CITY OF MADRAS
Request for Planning Commission Action

Date Submitted: November 30, 2011
Agenda Date Requested: December 7, 2011
To: Madras Planning Commission
From: Nick Snead, Community Development Director
Subject: **Park Place Subdivision Proposal (File # SD-11-1).**

PLANNING COMMISSION HEARING DATE: December 7, 2011

REQUEST: Tentative subdivision plan approval for a single phase, 42 lot subdivisions located in the Planned Residential Development (R-3) zoning district. The subject properties total 9.01 acres.

TENTATIVE PLAT

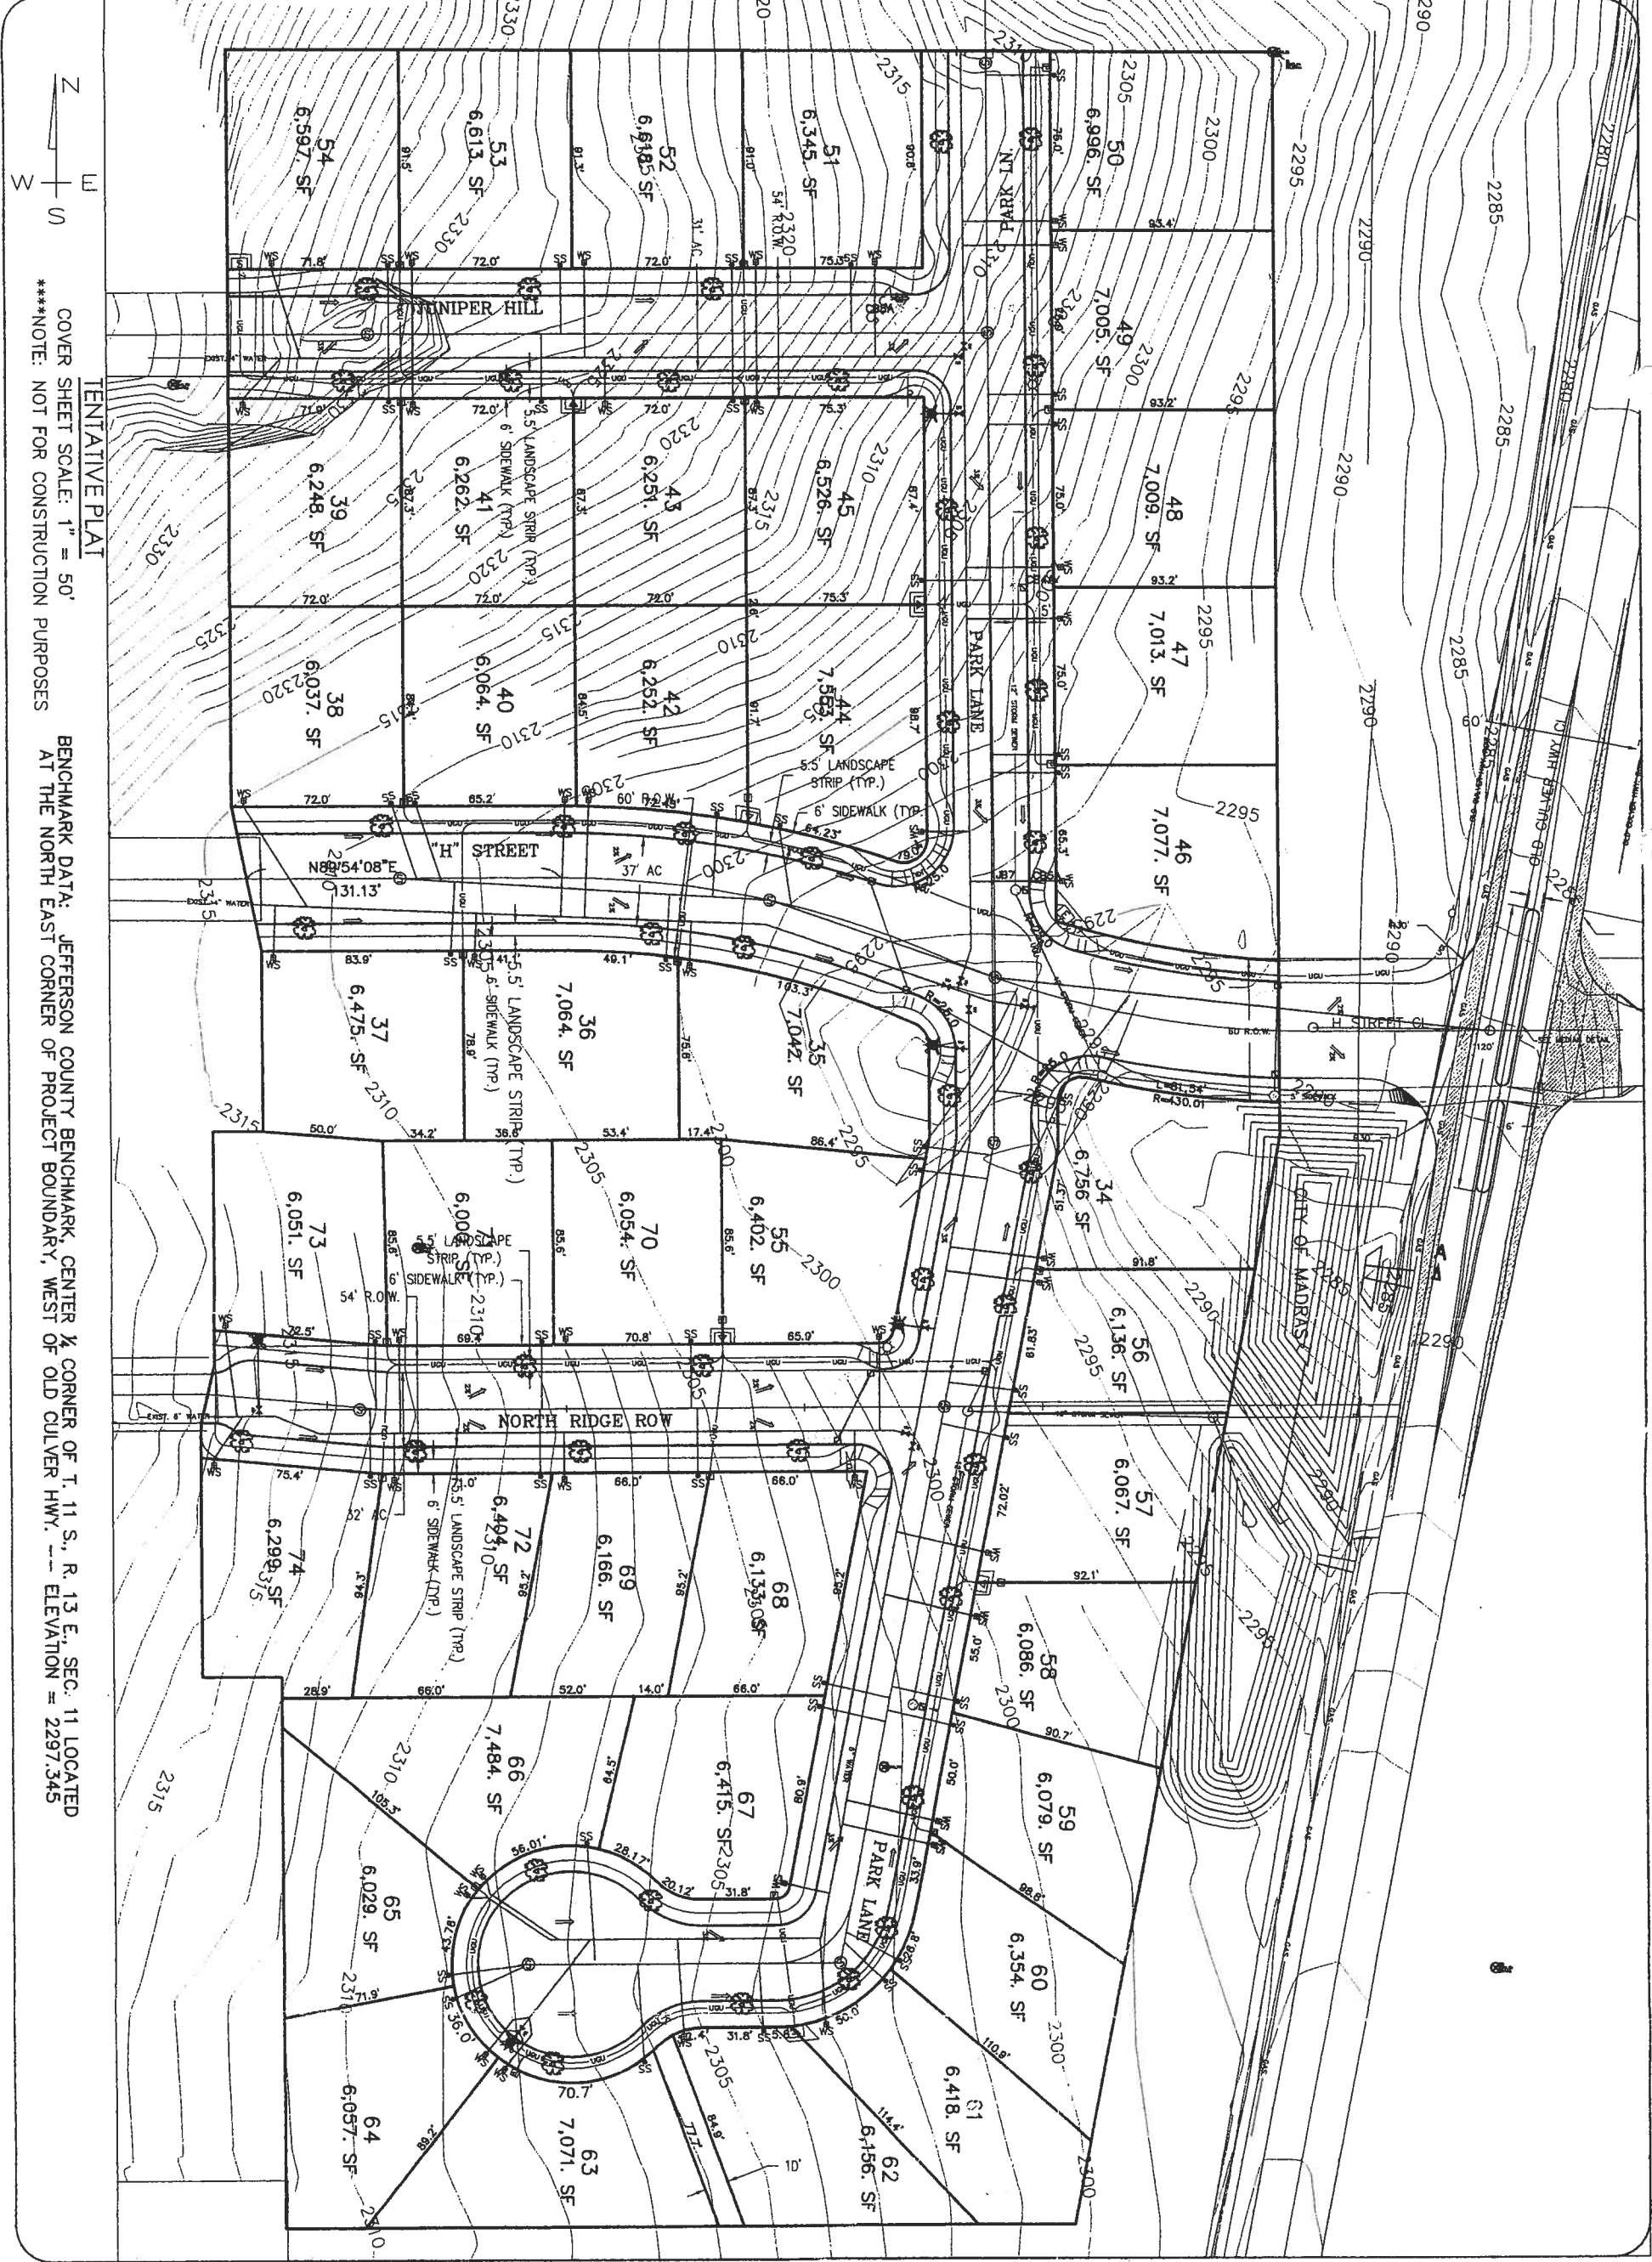
Oregon Department of Transportation: The approach is not permitted. As shown on the site plan, the design of the approach is not detailed enough. ODOT needs to review a more detailed drawing of the approach and pedestrian island in order to assess mobility impacts and mitigation. The applicant should work with ODOT District 10 on an approved design and permitting of the approach.

CONDITION OF APPROVAL: Prior to final plat, the applicant shall submit a revised tentative plan that clearly identifies the frontage length of lots 66 through 71 to the Community Development Department for review and approval. If lots 66 through 69 do not have at least 40 feet of frontage, the applicant shall submit a revised tentative plan to the Community Development Department for review and approval prior to final plat that shows that lots 66 through 69 have at least 40 feet of frontage (i.e. reconfigure lots).

As previously discussed the applicant’s tentative plan shows a 10 foot wide bicycle and or pedestrian access way between lots 65 and 66. The applicant shall clarify: 1) the intended uses of this portion of the subject properties; and 2) if access to this bicycle and pedestrian way will be given via a public access easement or public-right-of-way. Accordingly, the applicant shall submit a revised plan to the Community Development Department clarifying the intended use and type of access (i.e. easement or right-of-way) prior to final plat. Based on the applicant’s ability to comply with the imposed condition of approval, the Planning Commission finds and concludes that the above stated criterion is satisfied.

CONDITION OF APPROVAL: The applicant shall clarify: 1) the intended use(s) of the 10 foot wide access between lots 65 and 66; and 2) if access to this

bicycle and pedestrian way will be given via a public access easement or public-right-of-way. Accordingly, the applicant shall submit a revised plan to the Community Development Department clarifying the intended use and type of access (i.e. easement or right-of-way) prior to final plat.

CONDITION OF APPROVAL: The applicant/developer shall construct the frontage improvements along Culver Highway south of the "H" Street and Culver Highway intersection as shown on the tentative plan. Such improvement shall include a 6 foot wide property tight concrete sidewalk.
